TELETYPE CORPORATION
Skokie, Illinois, U.S.A.

INSTRUCTIONS FOR INSTALLING THE 402315 OR 402316 MODIFICATION KIT TO
CONVERT A 410001 OR 410009 CIRCUIT CARD TO A 410018 CIRCUIT CARD

INSTRUCTIONS FOR INSTALLING THE 406328 MODIFICATION KIT TO CONVERT A
410001 OR 410018 CIRCUIT CARD TO A 410009 CIRCUIT CARD

Fig. 1 -- Logic Card Positions

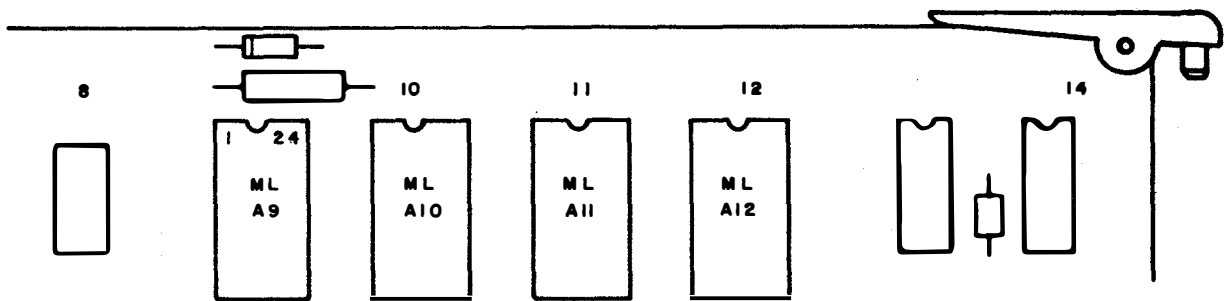
2.03   Use a 20 watt or less soldering iron, and a desoldering tool to remove the
ROMs from the pack locations (Fig. 1) indicated below:

|	
410001 Card Assembly Remove packs from positions: MLA9, MLA10 and MLA12. (For the 402315 Modification Kit, also remove MLA11.)	410009 or 410018 Card Assemblies Remove packs from positions: MLA9, MLA10 and MLA11.

Fig. 3 -- ROM Pack Installation for the 402315 or 402316 Modification Kit

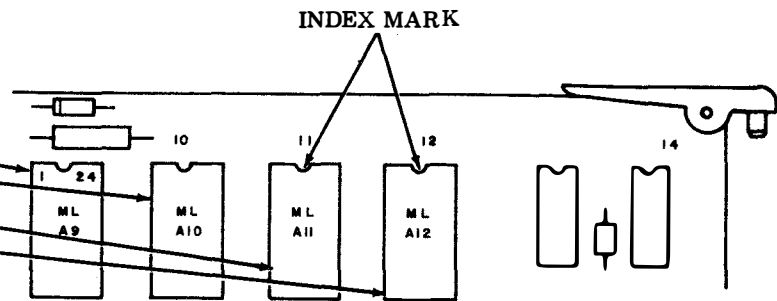
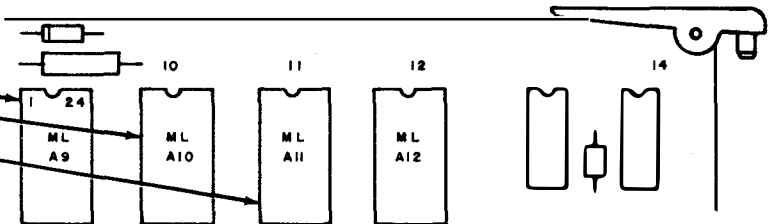
③ Install the ROM packs (Fig. 3) in the respective sockets. Make sure all of the
pack pins are inserted into the sockets and are not bent under. Use caution
when inserting the packs, because undue force could fracture the case, and/or
break off the pack pins. Make sure the index mark on the packs are toward the
top of the card. (Pin 1 is in upper left hand corner).

402315 Modification Kit --
Add the following ROMs
in the positions indicated:
MLA9 - 343766 ROM
MLA10 - 343767 ROM
MLA11 - 343768 ROM
MLA12 - 343765 ROM

402316 Modification Kit --
Add the following ROMs
in the positions indicated:
MLA9 - 343766 ROM
MLA10 - 343767 ROM
MLA11 - 343768 ROM

Fig. 4 -- Label Location

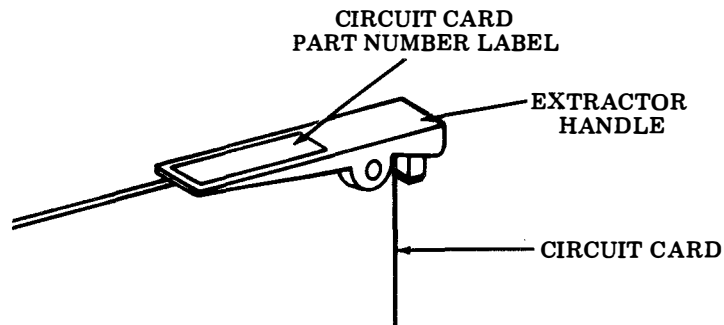
④ Remove old part number label (Fig. 4) from the extractor handle.

⑤ Replace with 341750 - "410018" Identification Label.

⑤Replace with 341749 - "410009" Identification Label.

Fig. 5 -- ROM Pack Installation for the 406328 Modification Kit

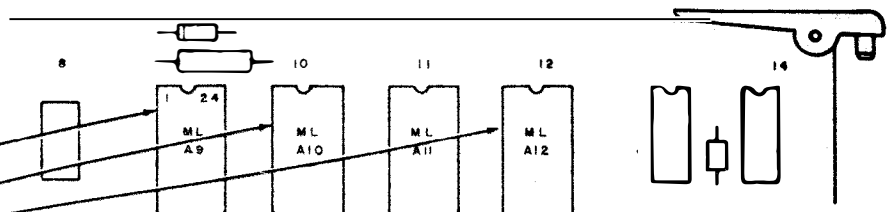
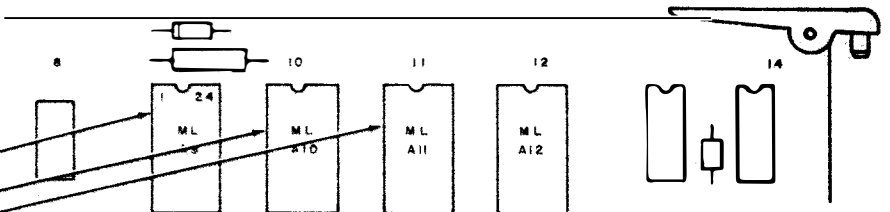
①Install the ROM packs (Fig. 5) in the respective plated through holes. **Make** sure all of the pack pins are inserted into the plated through holes **and are not** bent under. Use caution when inserting the packs because undue force could fracture the case and/or break off the pack pins. Make sure the index **mark on** the packs are toward the top of the card. (Pin 1 is in the upper **left** hand corner.)

406328 Modification Kit --
For conversion from a
410001 to a 410009 add the
following ROMs in the
positions indicated:

MLA9   - 343763 ROM
MLA10 - 343764 ROM
MLA12 - 343765 ROM

For conversion from a
410018 to a 410009 add
the following ROMs in
the positions indicated:

MLA9   - 343763 ROM
MLA10 - 343764 ROM
MLA11 - 341738 ROM
